March 14, 2018

Subject: Greenwood Aggregates Pit Violet Hill Licence Application
Response #2 to the Combined Level 1 / 2 Hydrogeological Assessment Peer Review

FIGURE 1: GROUNDWATER FLOW MAP

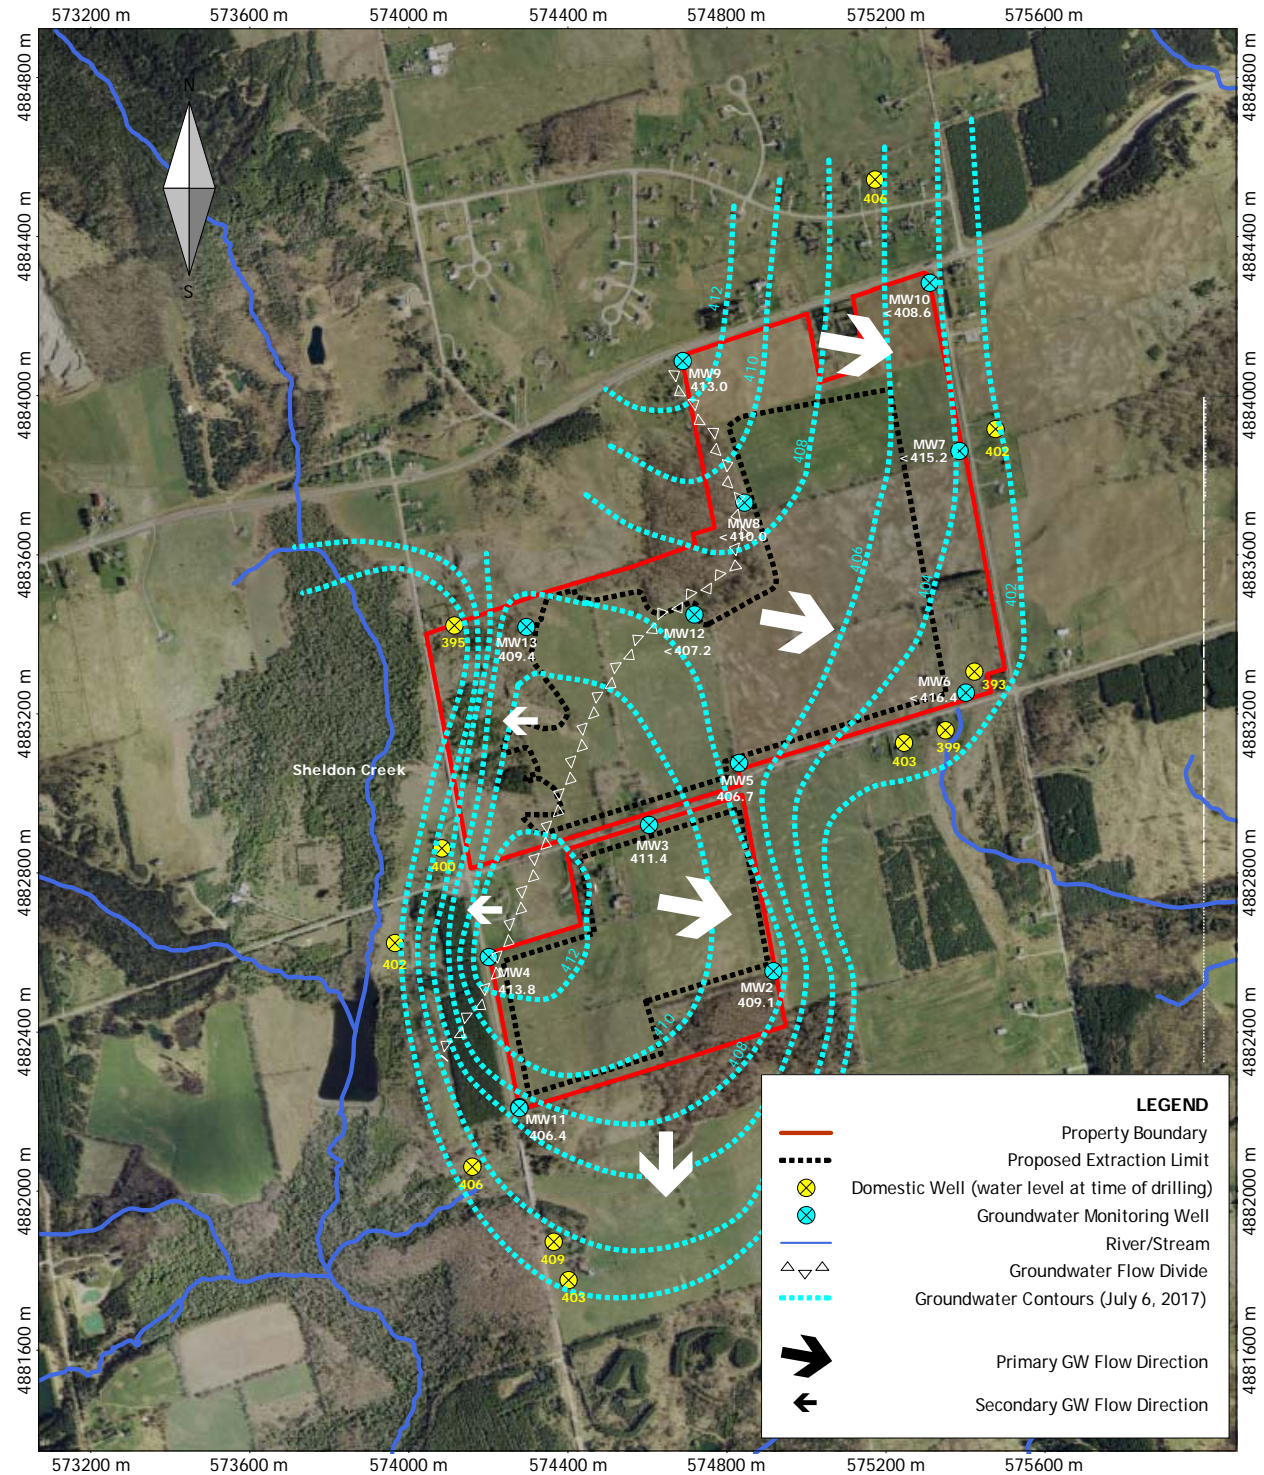
Groundwater watersheds are conceptually like surface water watersheds because groundwater flows from topographic highs (groundwater recharge areas) to topographic lows (groundwater discharge areas). The boundaries of surface water and groundwater watersheds do not always coincide exactly. Groundwater movement occurs in aquifer systems and is subject to hydraulic properties of the aquifer, input to (recharge) and outflow from (discharge) the aquifer system, and geological factors. Unconfined aquifers (the water table) mimic surface water watersheds but can vary slightly based on the conditions mentioned above. Whitewater has not stated that the two divides are equivalent / coincide, but that the flow directions are similar (primarily west and south, with a small easterly component).

Figure 8 from the Whitewater report (2016) has been revised to reflect the requested information (see Figure 1 appended), which includes the revised seasonal high-water levels, groundwater contours, and groundwater flow direction. The seasonal high-water levels which were used to create the groundwater flow map were measured on July 6, 2017. Selected representative domestic water well data have been used to assist in the mapping of the regional groundwater flow pattern. Domestic water level data was filtered based on geological descriptions, supply aquifer details, date of drilling, and pump test information to that the static water level could be used to aid in defining the regional groundwater flow conditions (regional high and low groundwater elevations).

The results show that the primary groundwater flow direction is east with a southerly component. A small portion of the site has groundwater flowing west toward the Violet Hill Wetland. The updated mapping further supports the groundwater flow interpretation presented in the Whitewater report (2016).

FIGURE 2: UPDATED GW HYDROGRAPH

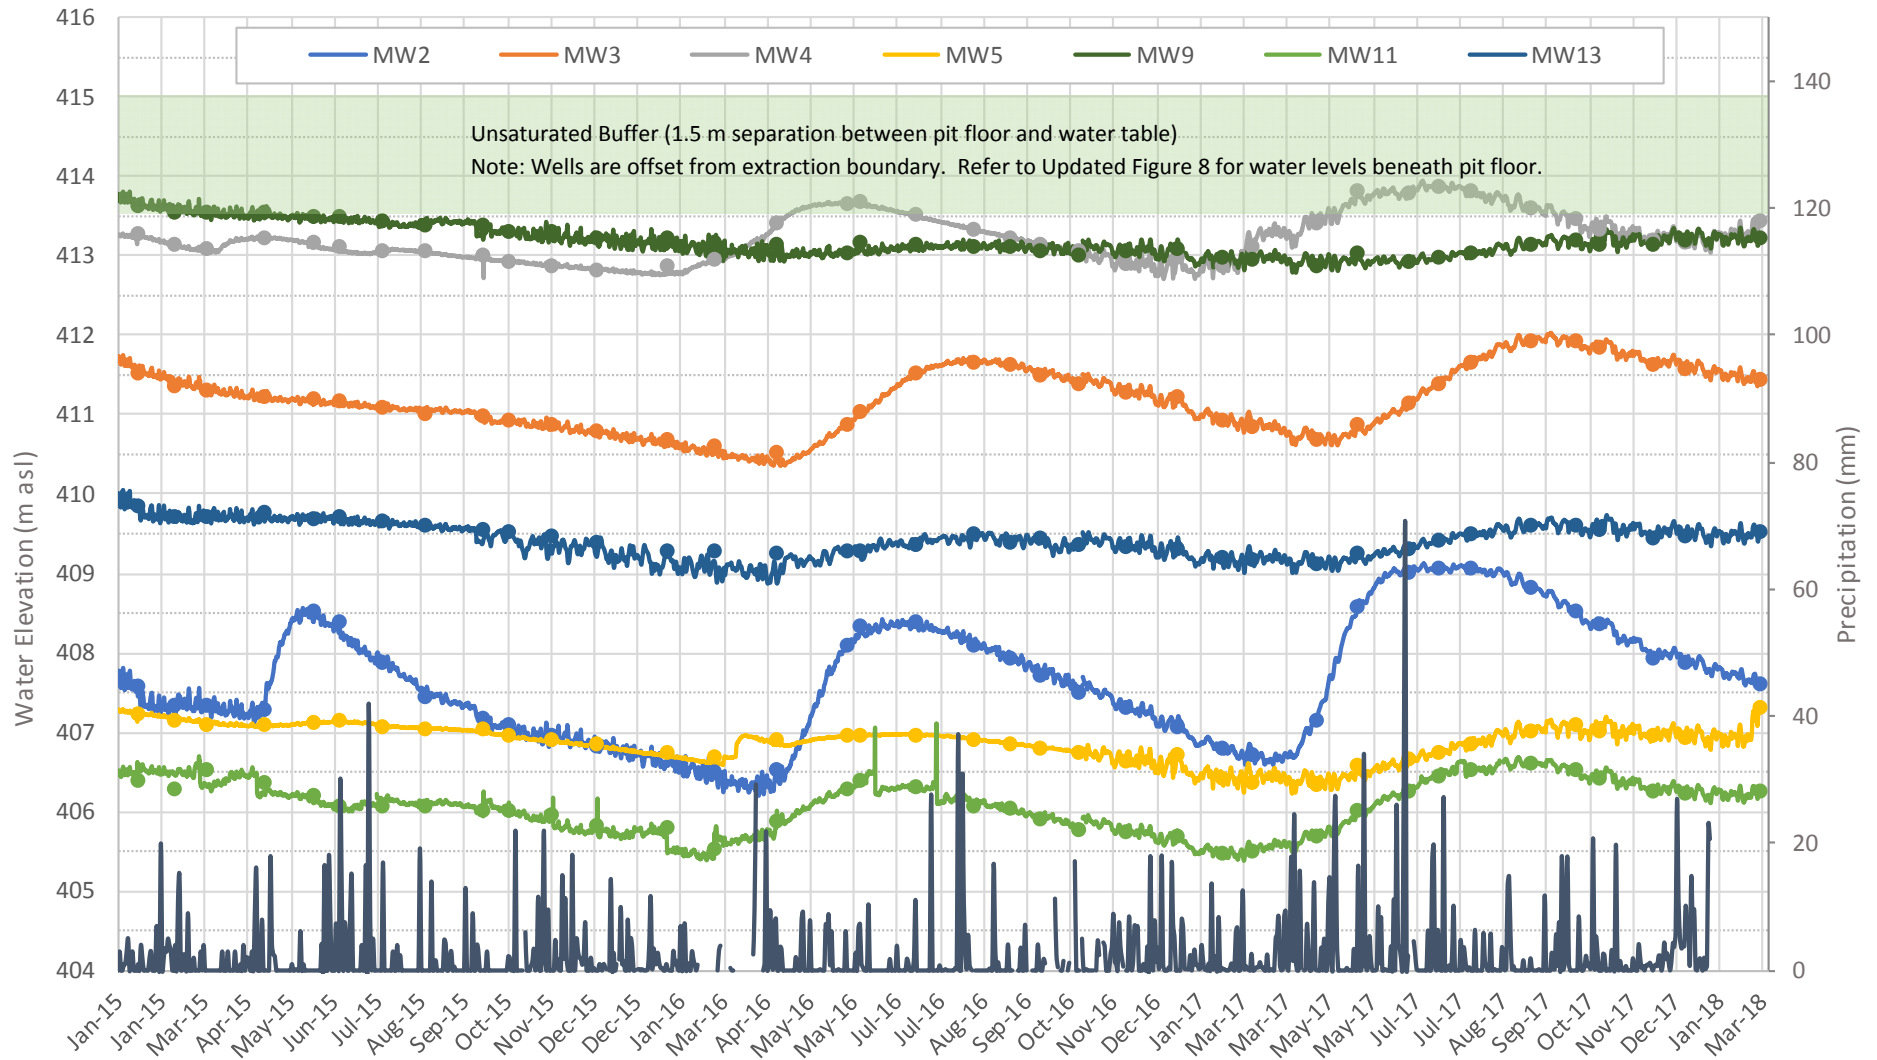
Burnside has relied on the cross sections presented in the 2016 report to compare the proposed pit floor elevation to the established water table. It is noted that discrepancies in the cross sections provide insufficient data to determine that the base pit floor elevation (415 masl) will provide a 5 m (*correct value is 1.5 m, not 5 m*) separation from the established water table elevation.

It has been requested that cross sections should be provided in greater detail and should incorporate the spatial variations in the groundwater table derived from the groundwater contour map (Figure 1). To obtain the vertical scale resolution requested (i.e., to distinguish true separation depths), the cross sections would require being constructed at a vertical exaggeration greater than 20x. Too much vertical exaggeration can distort terrain to the point of misrepresentation. Therefore, it is felt that an updated hydrograph, which compares water levels to the proposed pit floor elevation and the revised Figure 8 will provide a clearer understanding of the proposed operation and site conditions.

The updated water levels are provided in Figure 2. For visual purposes, the 1.5 m unsaturated buffer zone beneath the proposed pit floor (415 masl) has been included. All the wells, except for MW4 and MW9 have seasonally high-water levels that are well below the 1.5 m buffer. MW4 and MW9 are both located upgradient from the proposed extraction boundary (40 and 200 m, respectively) and as a result, will have water levels that are higher than the interpreted levels across the pit floor (Figure 1). Based on the groundwater flow contours, the water table elevation ranges between a high of approximately 413 masl (south-west of MW4) to a low of 403 masl (near MW6) beneath the proposed extraction area. Therefore, the pit floor will remain 1.5 m above the water table.

The highest water levels report across the site (413 masl) are found in Phase E of the operations plan, which is the final area of the proposed extraction plan. On-going monitoring will confirm that extraction remains at or above the 1.5 m separation distance from the established water table (seasonal high) to ensure compliance.
